TO: T10 Membership
FROM: Paul A. Suhler, Quantum Corporation
DATE: 29 May 2008
SUBJECT: T10/07-469r4, ADT-2: Internet ADT (iADT)

Changes to ADT-2 rev. 5

Figure 5 – ADT serial port example

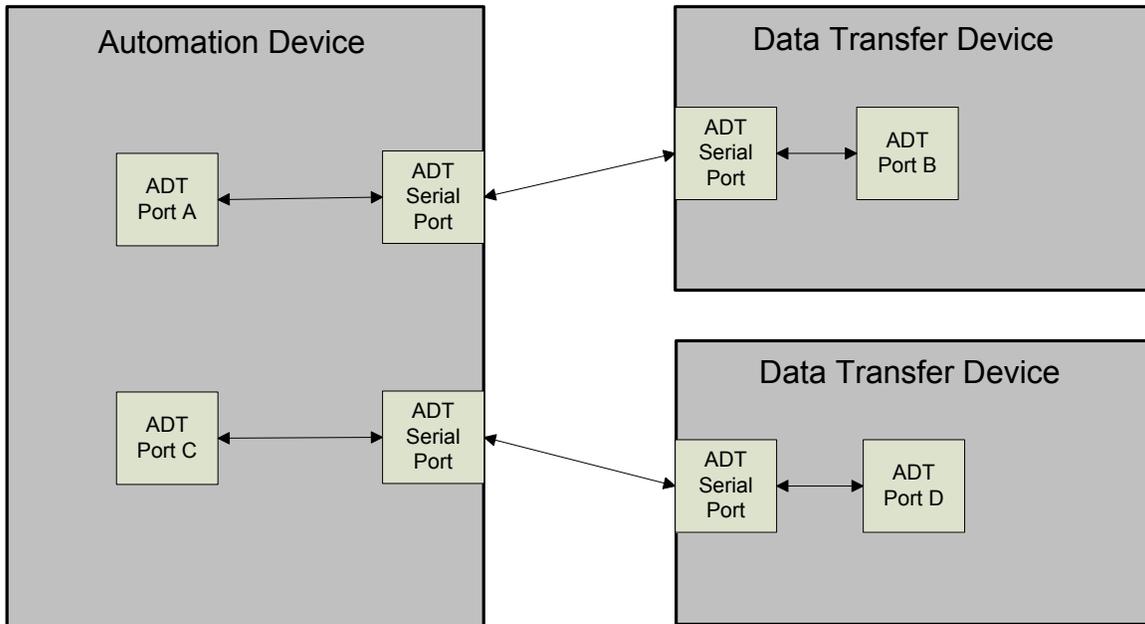
The term ADT serial port refers to an interconnect port using the ADT serial bus and the ADT serial interconnect layer. A single ADT port may use an ADT serial port for connection with another device. Figure 5 shows connections corresponding to Figure 3. ADT port A is connected with ADT port B, and ADT port C is connected with ADT port D.

Figure 6 – ADT Ethernet port example

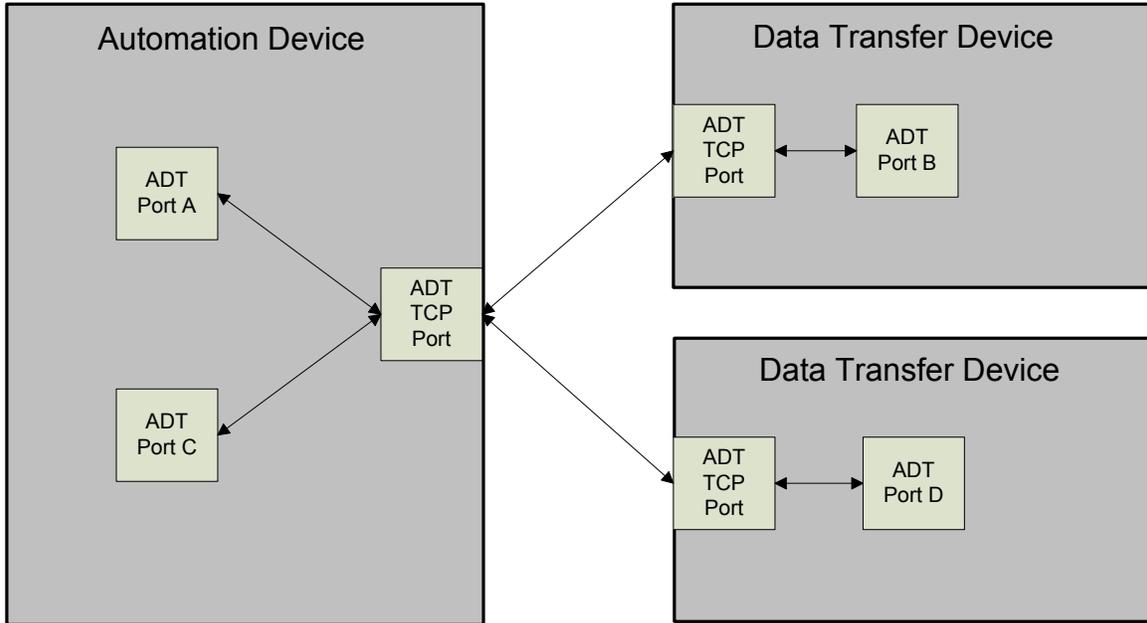
The terms ADT TCP port and ADT UDP port refer to an interconnect port using the ADT Ethernet bus and the ADT TCP or ADT UDP interconnect layer, respectively. Multiple ADT ports in one device may share a single ADT TCP port for connection to other devices. Figure 6 shows two pairs of ADT ports connected by ADT TCP ports, corresponding to the connections shown in Figure 3. ADT port A is connected to ADT port B, and ADT port C is connected to ADT port D.

Figure 7 – ADT UDP port example

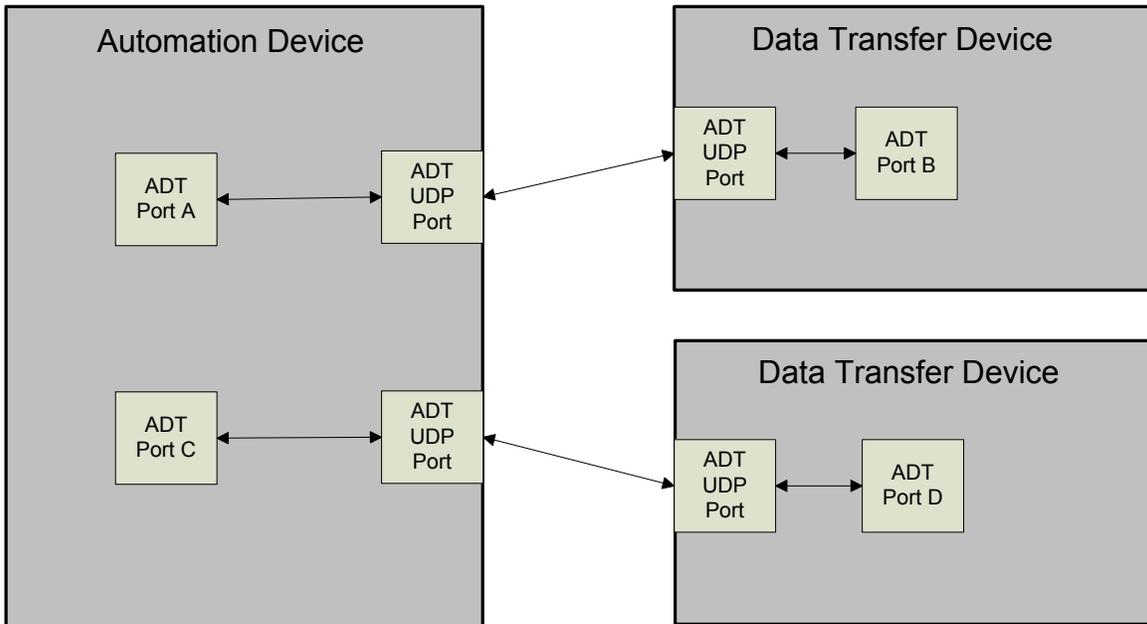
A single ADT port may use an ADT UDP port for connection with another device. Figure 7 shows connections corresponding to Figure 3. ADT port A is connected with ADT port B, and ADT port C is connected with ADT port D.
